# APPROVED MINUTES

## October 21, 2021 Standards Committee Meeting

RE: Minutes from the October 21, 2021 Standards Committee Meeting

PROPOSED SOLUTION: Revise and update the standard drawing series on flagger operations (E 801-TCFO) and create a new series for mobile operations (E 801-TCMO). Delete unnecessary and duplicate details from the temporary closure series (E 801-TCTC).

E 801-TCTC-05 TRAFFIC CONTROL FOR DAYTIME LANE CLOSURE (WITH MARKUPS)

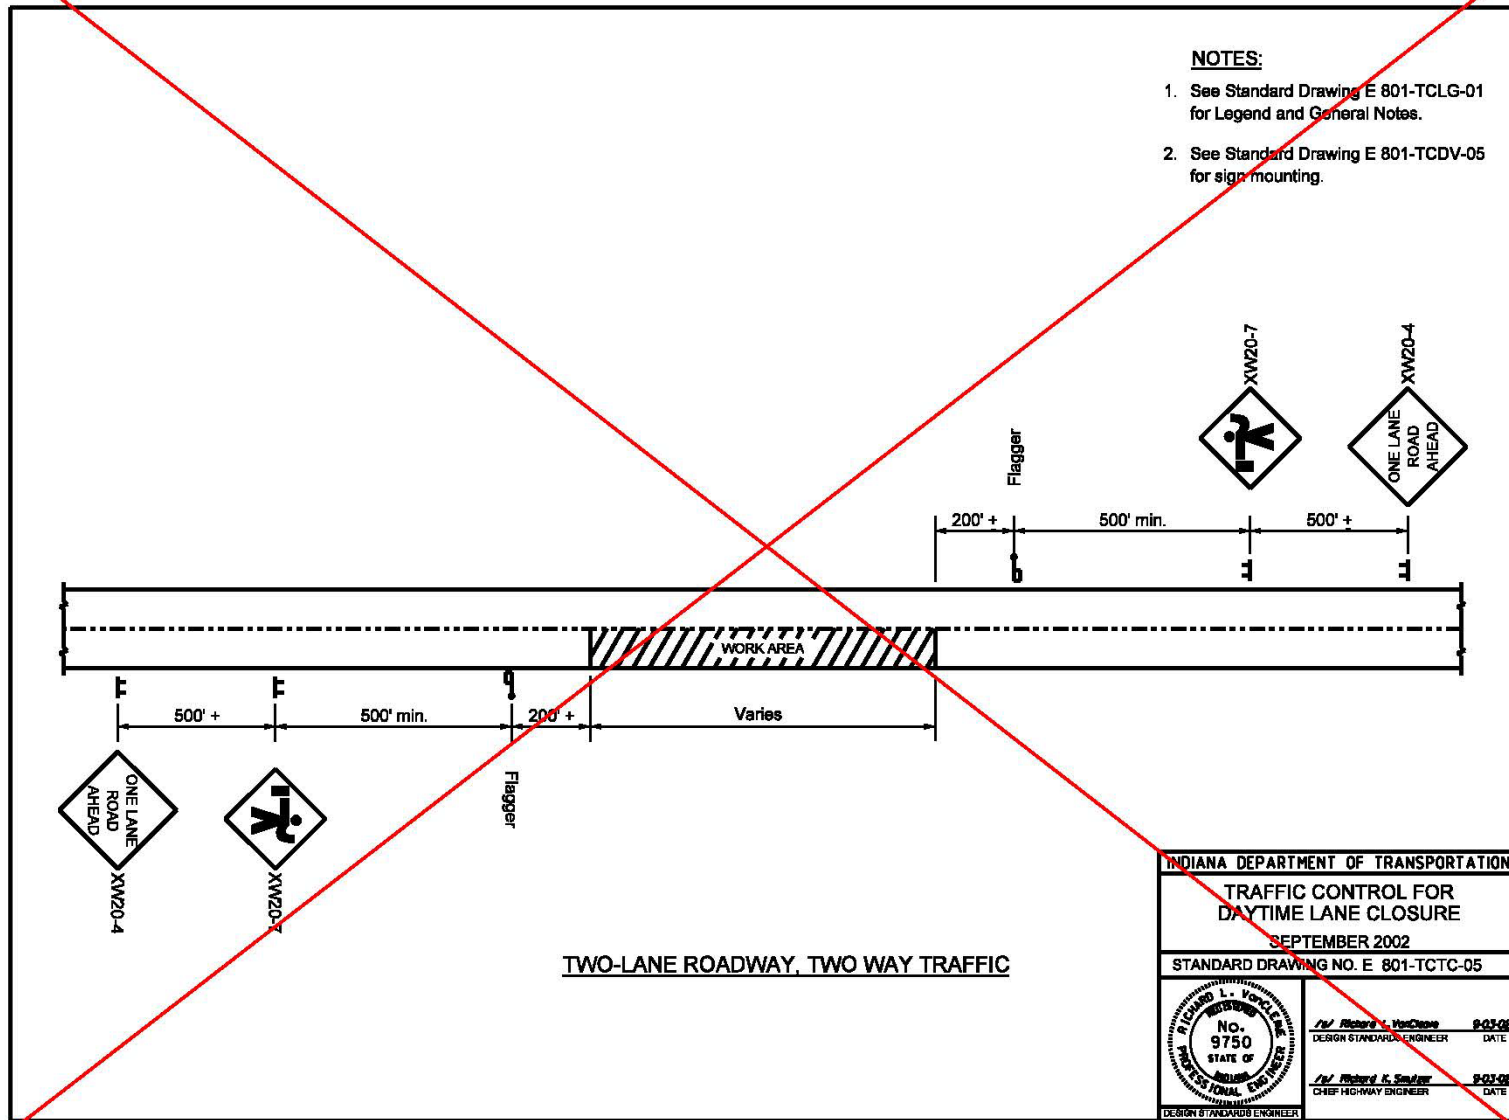
Delete (Addressed in 801-TCFO Series)

E 801-TCTC-06 MAINTENANCE OF TRAFFIC FOR RPM CASTING INSTALLATION (WITH MARKUPS)

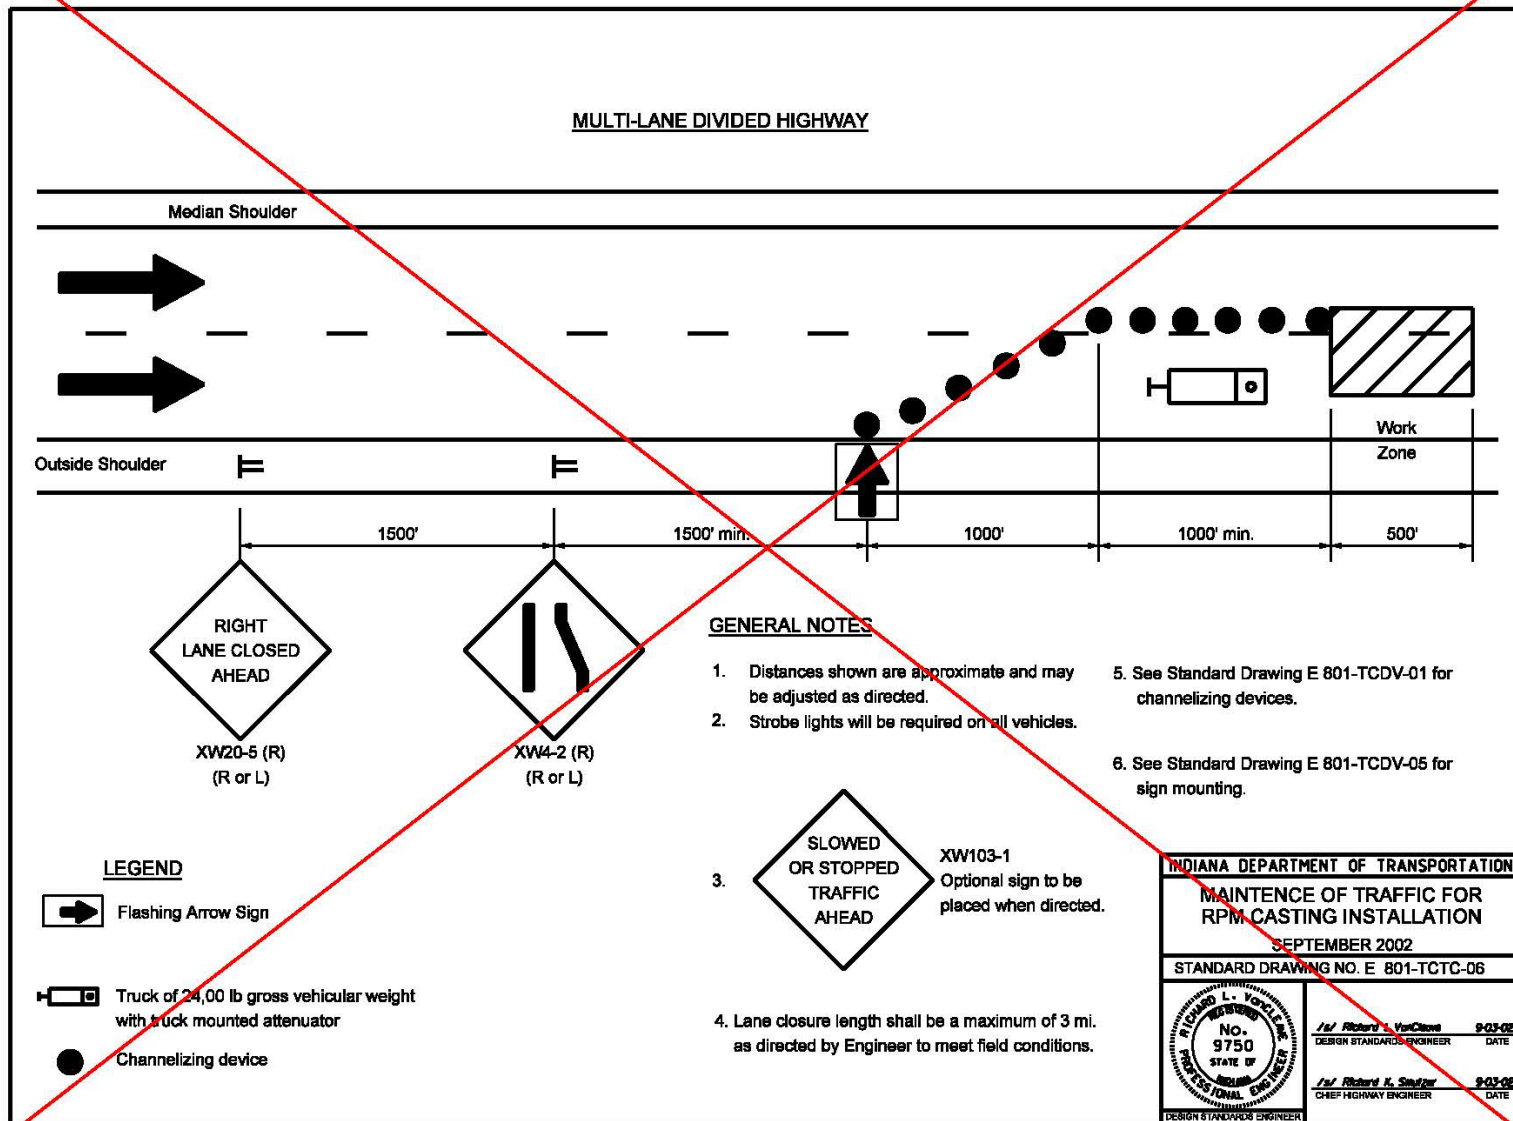
(Duplicate of 801-TCFO-03)

E 801-TCTC-07 MAINTENANCE OF TRAFFIC FOR RPM CASTING REPLACEMENT (WITH MARKUPS)

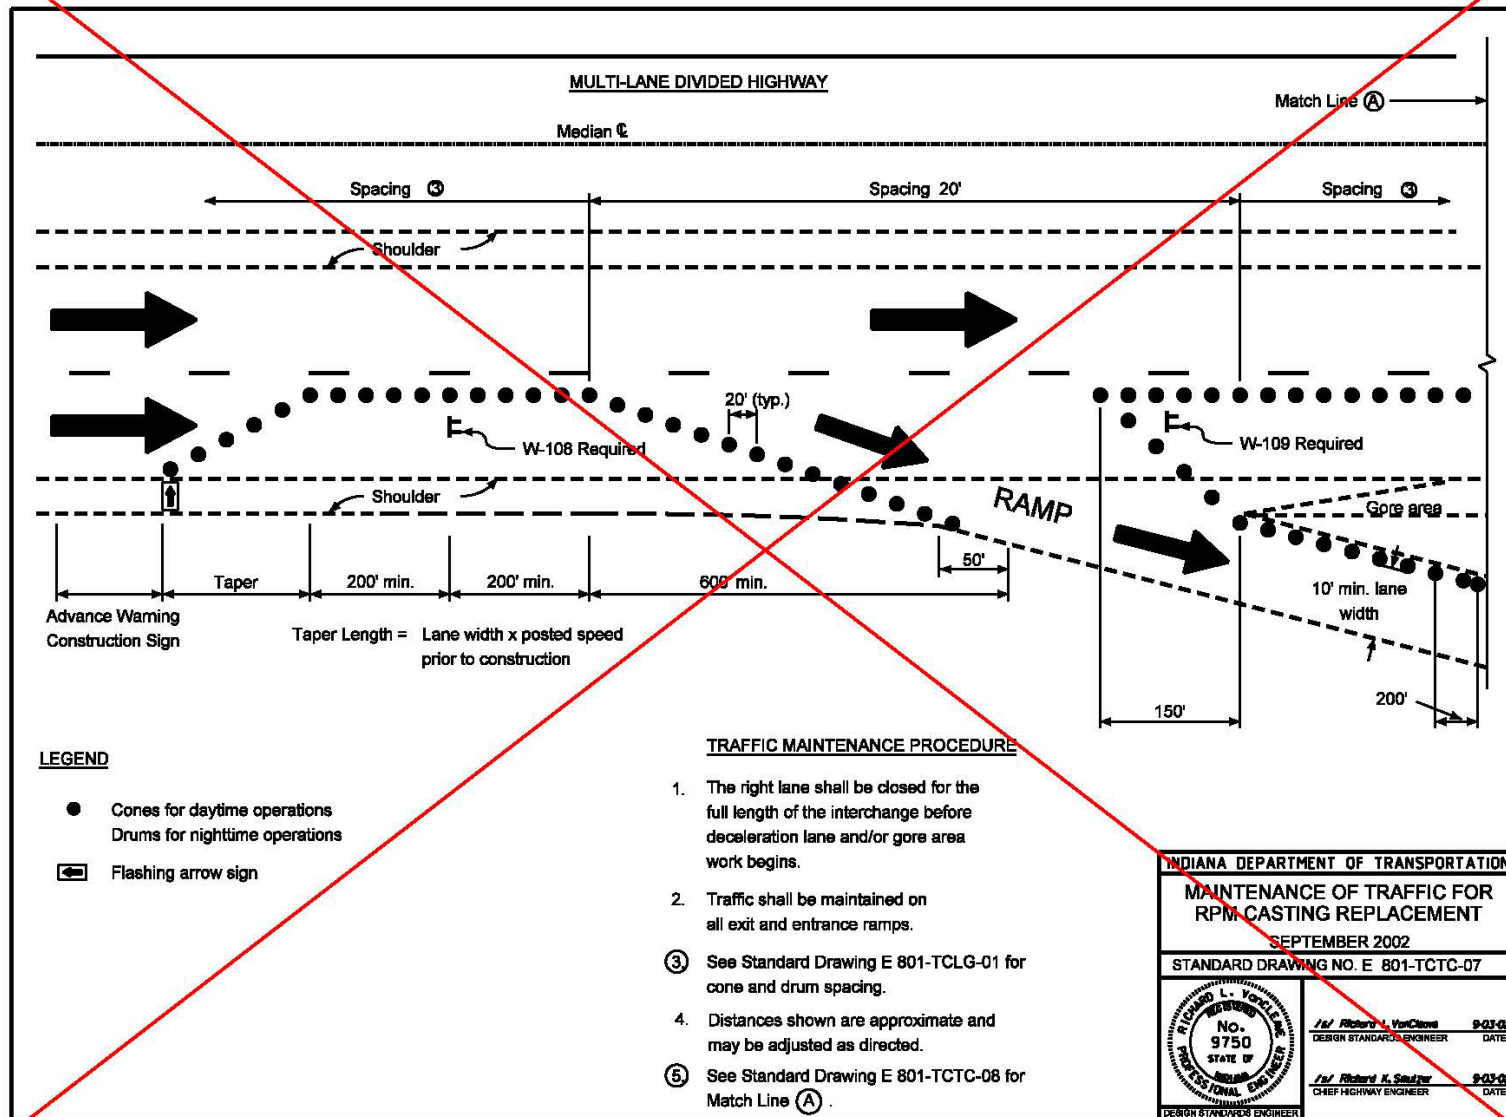
(Addressed in 801-TCLC-15)

E 801-TCTC-09 MAINTENANCE OF TRAFFIC FOR RPM REFLECTOR REPLACEMENT (WITH MARKUPS)

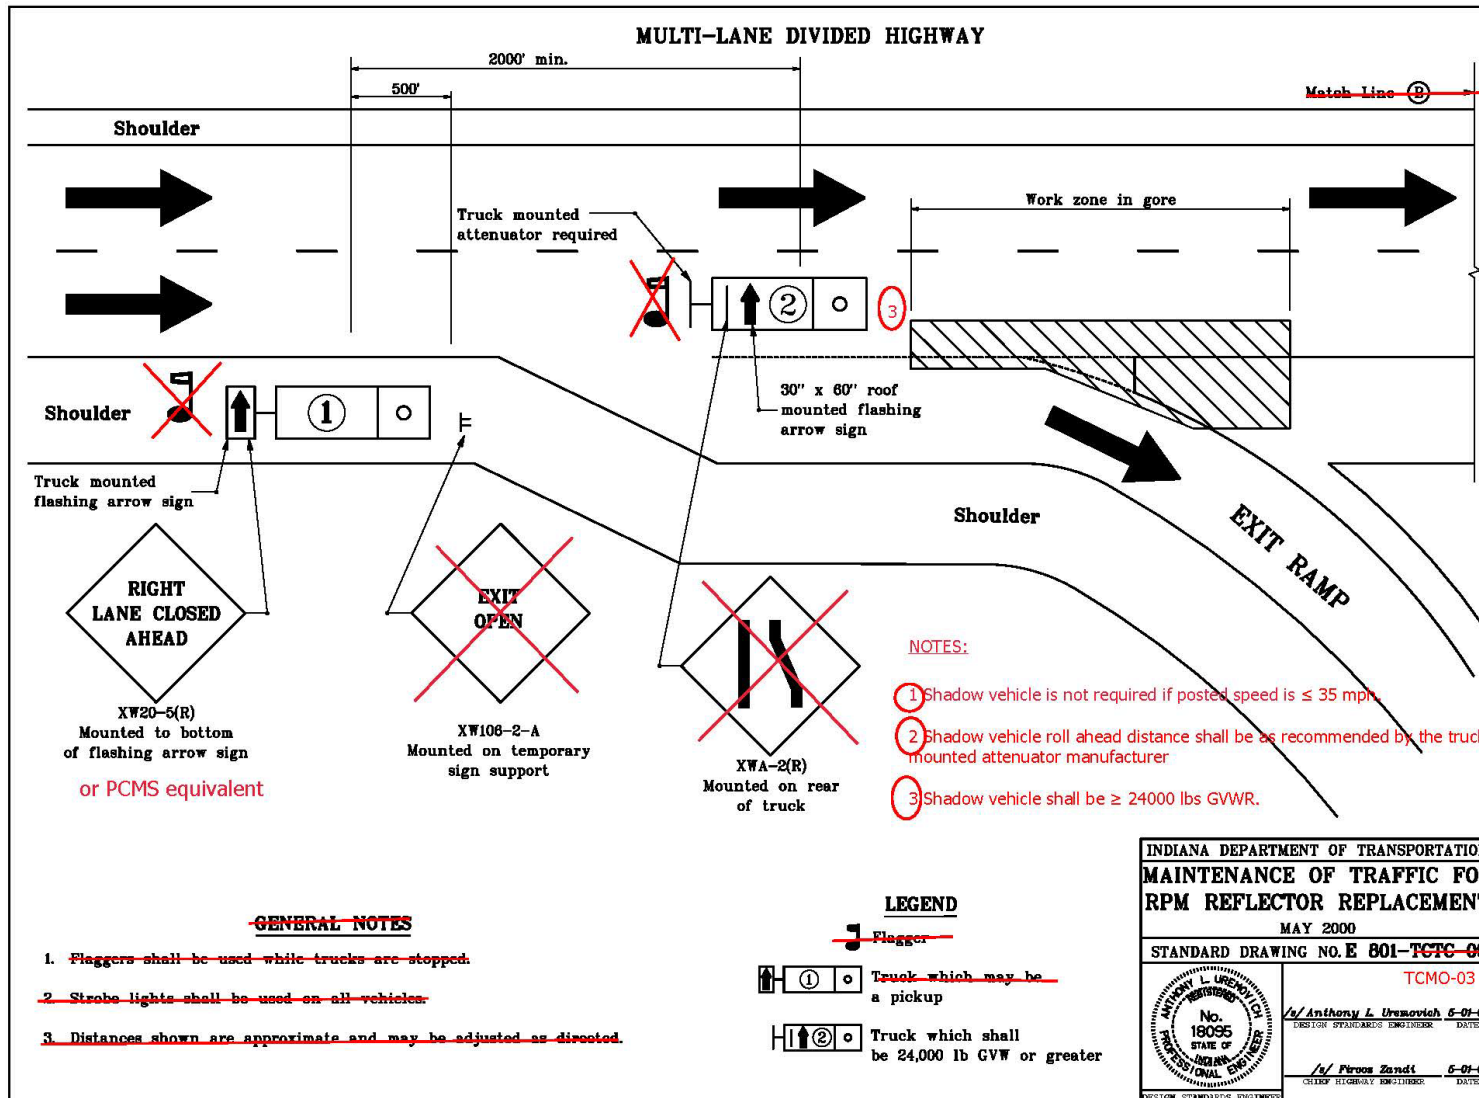
Move to New Series on Traffic Control for Mobile Operations

E 801-TCTC-10 MAINTENANCE OF TRAFFIC FOR RPM REFLECTOR REPLACEMENT (WITH MARKUPS)

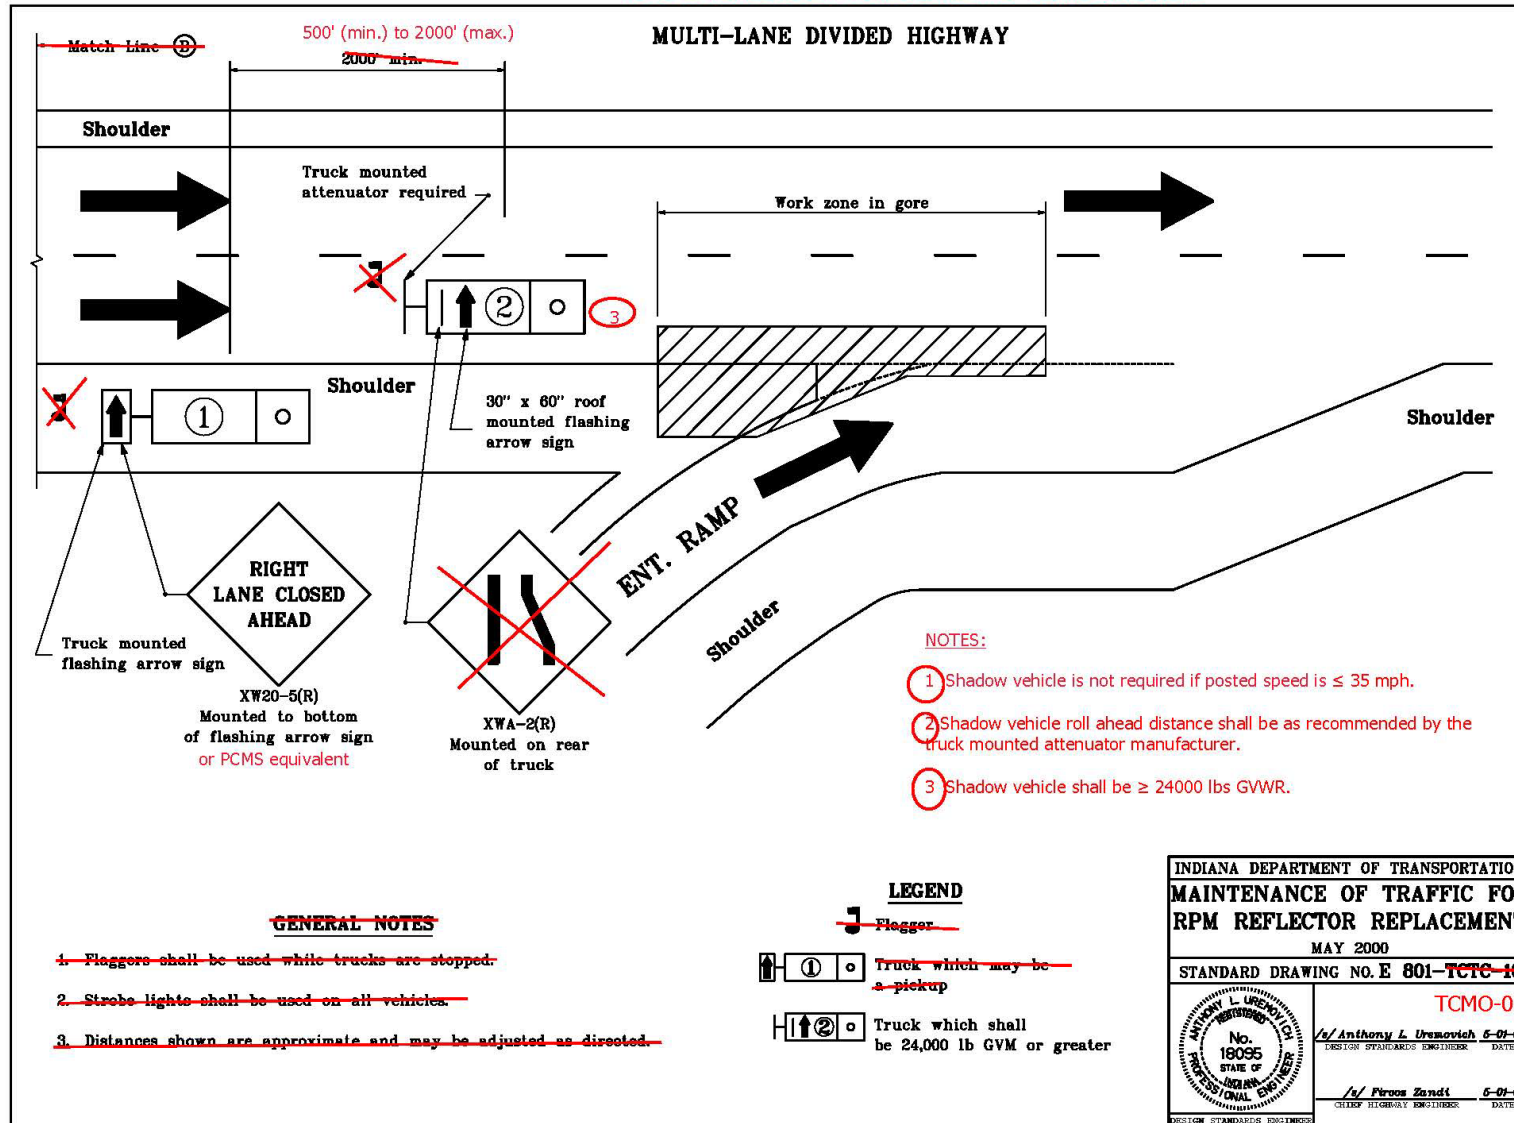
Move to new series on Traffic Control for Mobile Operations
